V2500-A1 PROPULSION SYSTEMS SERVICE BULLETIN

This document transmits Revision 1 to Service Bulletin EV2500-72-0431 and Revision 1 to the Supplement

Reason for change
To add spacer which is used
to rework sub-assembly
6A8100.

ENGINE – ACTUATING MECHANISM HP COMPRESSOR VARIABLE VANES – INTRODUCTION OF STAGE 6
UNISON RING ASSEMBLY WITH A REVISED ONE PIECE LEVER PIN BUSH

Typical Section Through HP Compressor
Figure 1

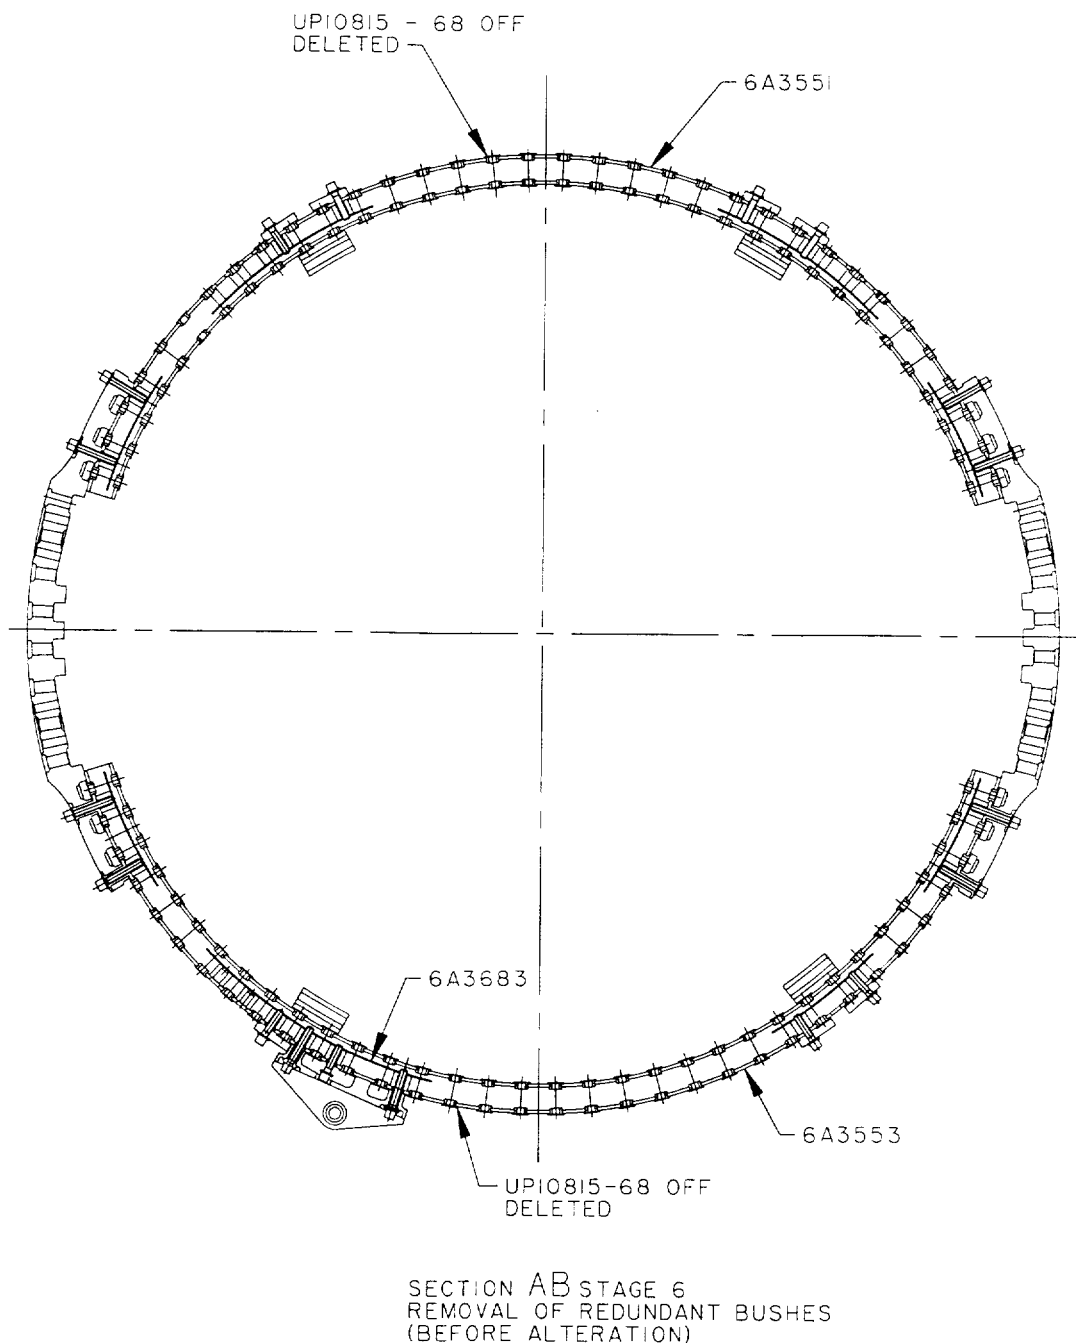
PROCEDURE	RELATED DATA
(i) Drill the head of the bush (UP10815 – 136 off) until the head is released	See Figure 1 and Figure 2. Use a drilling machine with a 0.307in. (7,8 mm.) diameter drill.
(ii) Push the bush from the hole	Use a round bar.
(iii) Remove the bush and brackets from the channel and retain the brackets	
(b) Clean the bush location holes in the ring	See Figure 2. Use a soft clean cloth and air blast, remove the sharp edges around the holes. Use standard workshop equipment.
(c) Visually examine and measure the dimensions of the bush location holes	See Figures 2, 3 and 4. Examine the interference on the diameter. Reject if the location hole is oversize.
(d) Remove UP11118 spacers (2 off) on bracket 6A3683	See Figure 5. Use portable grinding equipment to remove existing welds. After removal, bracket surface to be made smooth.

Installation of New Bushes
Figure 3

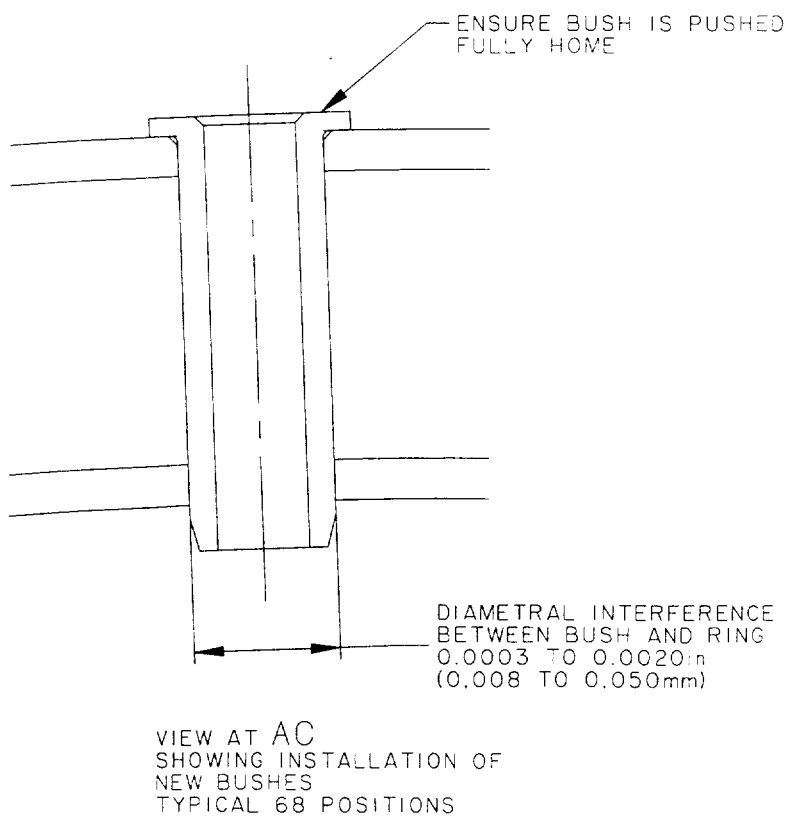
- (l) Install brackets into position See Figure 3.
Use hand tightened No.10 (0.190in., 4,82 mm.) diameter UNF bolts as necessary, to hold the brackets in position.

- (m) Install the new bushes into the holes
- (i) Push the bush fully into position in the hole See Figures 3 and 4.
Use bushes UP12206 - 68 off.
- (ii) Visually inspect the bush location See Figure 4.

Rework of Bracket Assembly
Figure 6

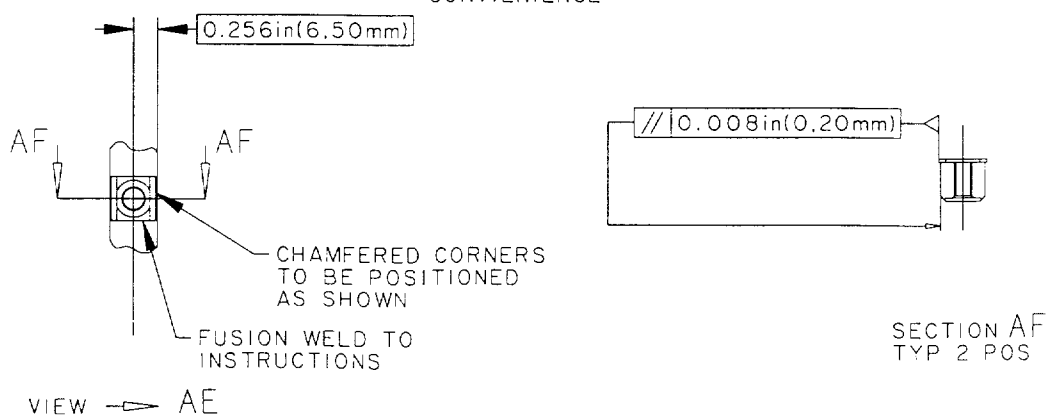
- (e) Position UP12172 new spacers (2 off) on bracket See Figure 6.
Refer to SPM, TASK 70-31-02-310-501.
Use 2 equispaced welds per spacer.
Use CoMat 03-204 filler material if required.

- (f) Do a visual inspection of the welds See Figure 6.
Use workshop inspection equipment.
Cracks are not permitted.
- (g) Do a local penetrant crack test of the reworked areas See Figure 6.
Refer to SPM, TASK 70-23-05-230-501.
Use CoMat 06-022 fluorescent penetrant with penetrant crack test equipment.
Cracks are not permitted.

- (h) Visually examine and measure the dimensions of the reworked areas See Figure 6.
Use workshop inspection equipment.
- (i) Install AGS3731 wire thread inserts (2 off) in spacers See Figure 7.
Refer to SPM, TASK 70-35-08-300-501, SUBTASK 70-35-08-350-002.
Use standard workshop equipment.

Bracket Assembly - After Rework
Figure 7

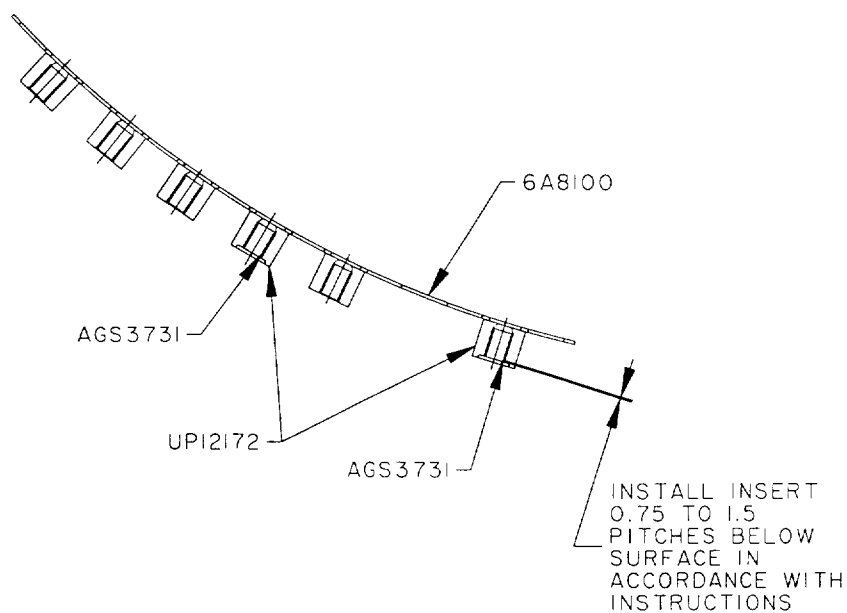
- (j) Visually inspect wire thread inserts See Figure 7.
Refer to SPM, TASK 70-35-08-300-501, SUBTASK 70-35-08-220-001.
- (k) Cancel the existing bracket part number and re-identify with the new part number Use vibro-engraving equipment.
Refer to SPM, TASK 70-09-00-400-501, SUBTASK 70-09-00-400-001.
